NRC RAI Letter Nos. ML19032A396 and ML19032A397 Dated February 1, 2019

Section I – Fluence

RAI 3.5.2.2.2.6-1

Figure 5.7. Effect of gamma radiation on the residual compressive strength of concrete. (Kontani et al. 2010)

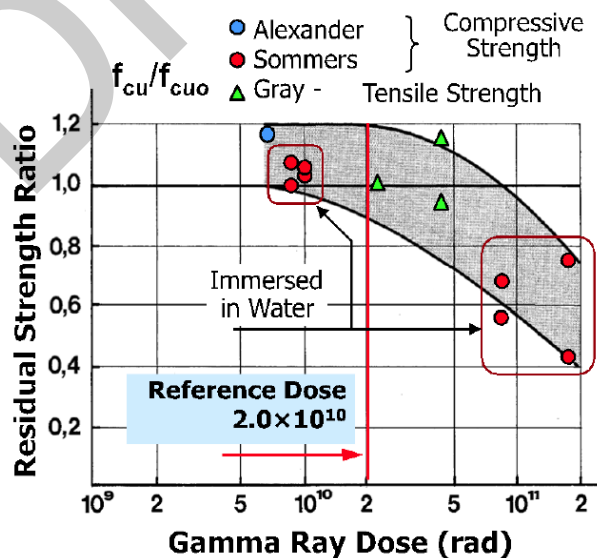
With regard to considerations such as the gamma dose rate, carbonation of concrete, aggregate, cement type, w/c ratio, and operating temperature of the concrete at PTN PSW versus the test specimens used in the Maruyama study: explain how the conclusions in Maruyama's paper can be used to assume that there is no degradation in material properties due to gamma dose, or provide justification for why such comparison between the PTN PSW and Maruyama study is unnecessary.

As noted in PTN SLRA 3.5.2.2.2.6, Rev. 1 (page 12 of 19 of the attachment to Reference 1), gamma irradiation up to 2.3×10^{10} rad likely has no effect on material properties of concrete. Additionally, NUREG/CR-7171 (Reference 2), Section 5.2 used 2.0×10^{10} rad (i.e., 2.0×10^5 kGy) as the critical level for gamma exposure when assessing the reduction of concrete strength under nuclear irradiation (as shown in Figure 5.7 excerpted and reprinted below from Reference 2). Concrete structures were considered to be sound as long as the level of radiation did not exceed this critical level.

This figure presents a plot, prepared by Kontani et al. (2010), of the same test data collected by Hilsdorf et al. (1978), showing the effect of gamma rays on the residual compressive and tensile strengths of concrete. In the figure, the reference dose is shown as 2.0×10^{10} rad.

Additionally, as noted in the response to RAI 3.5.2.2.2.6-2 (Attachment 2 to this letter), the Westinghouse-calculated gamma dose incident on the PTN PSW at the end of the SPEO is 1.44×10^{10} rad. The dose calculated by FPL for the gamma dose used in the concrete degradation evaluation was 1.9×10^{10} rad incident on the PSW at the end of the SPEO. Considering the very conservative gamma dose used in the concrete degradation evaluation, and the 2×10^{10} rad critical level from NUREG/CR-7171, concrete degradation due to gamma radiation of the PTN PSW is not expected through the SPEO.
